MINOR REPAIR PERMIT

ON-SITE SEWAGE DISPOSAL SYSTEM HOWARD COUNTY HEALTH DEPARTMENT BUREAU OF ENVIRONMENTAL HEALTH

SUBDIVISION: Simpson Woods LOT NUMBER: 16

ADDRESS: 7225 Meadow Wood Way PROPERTY OWNER: Arnold Prada

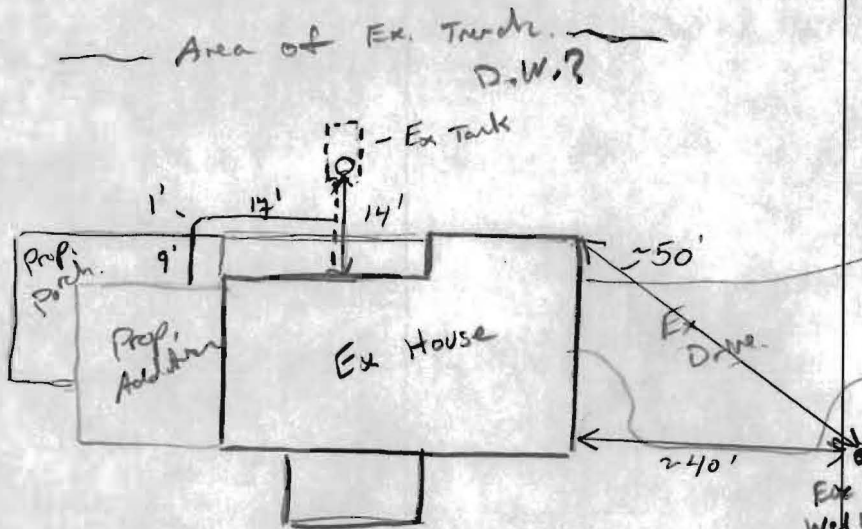
TRENCHES:	No Alteration to Trench Distribution Systems are Permitted under this Minor Septic Repair Permit
LOCATION:	Run 4" gravity line from new addition to existing septic system.
PURPOSE:	Minor alterations/repairs to an existing septic system.

INSTALLATION 1/25/08 New 4" xh 40 line installed per plan coming from 'new' addition to ex. line into tank. Plumber used a 'T' to tie line into ex. line. OK to cover. (KW)

SITE PLAN

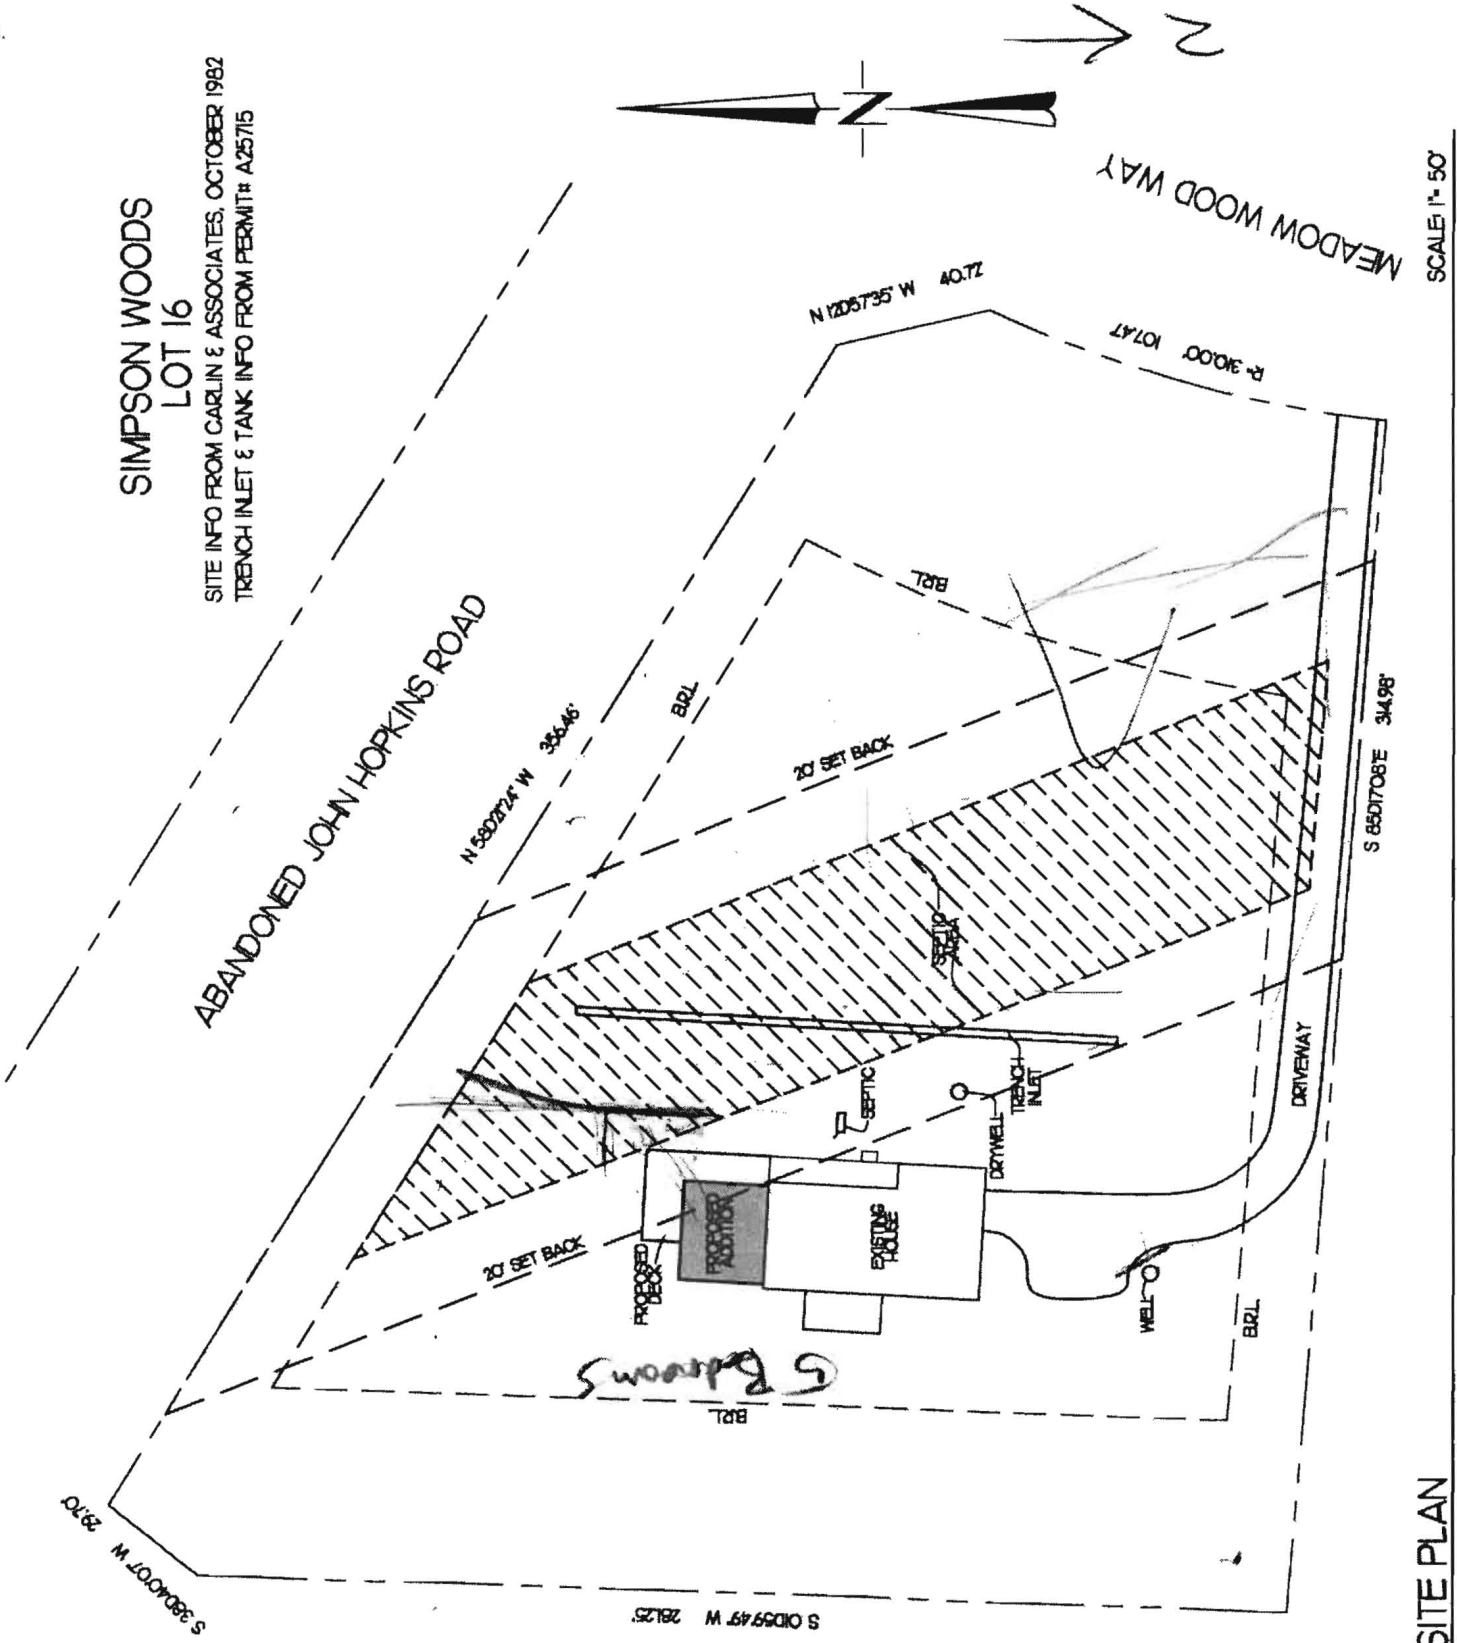
Attached please find a copy of site plan for Simpson Woods Lot 16. The owners would like a 24' addition on to the side of the existing house with a wrap around porch. (See attached drawing) The drawings received from the Health Department depict the septic field close to where we would like to put the addition. It appears the addition will cross the 20' min. set back requirement.

In addition, the 100' B.R.L. as shown on the original site plan was required when John Hopkins Road was proposed. Since that time the county has abandoned John Hopkins Road. Our client has purchased the right away (parcel 468, Liber 2317, Folio 339) from the county. After talking to Cindy Hamilton, she said we could use a B.R.L. of 10 or 20 feet. We would like to find out what process we need to take to change the location of the septic field or waive the set back requirements for this building addition.

SITE PLAN

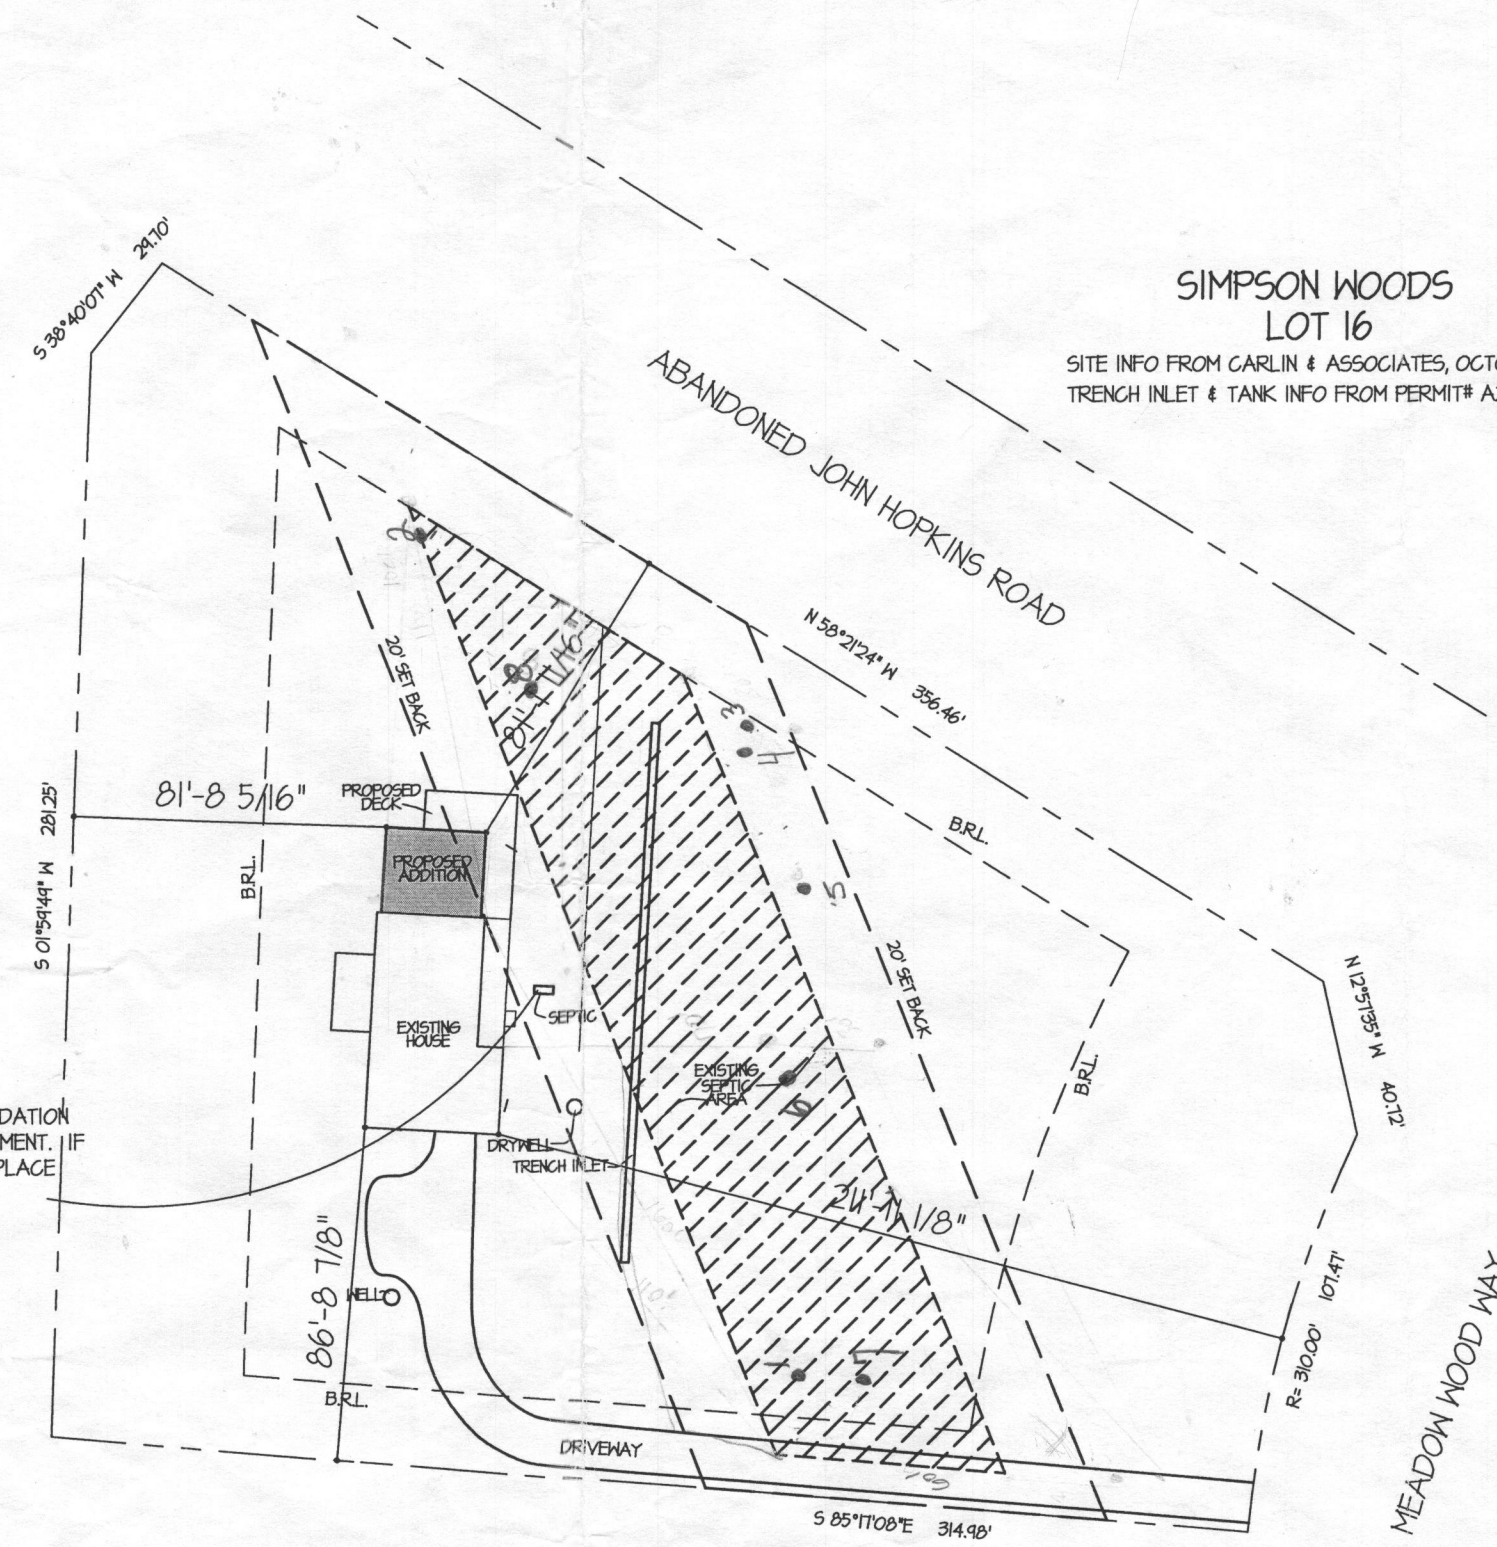
VERIFY EXISTING 1250 GAL. SEPTIC TANK WHEN FOUNDATION IS EXCAVATED. SUBMIT FINDINGS TO HEALTH DEPARTMENT. IF TANK IS FOUND TO BE SMALLER THAN 1250 GAL., REPLACE EXISTING TANK W/ 1250 GAL. TANK.
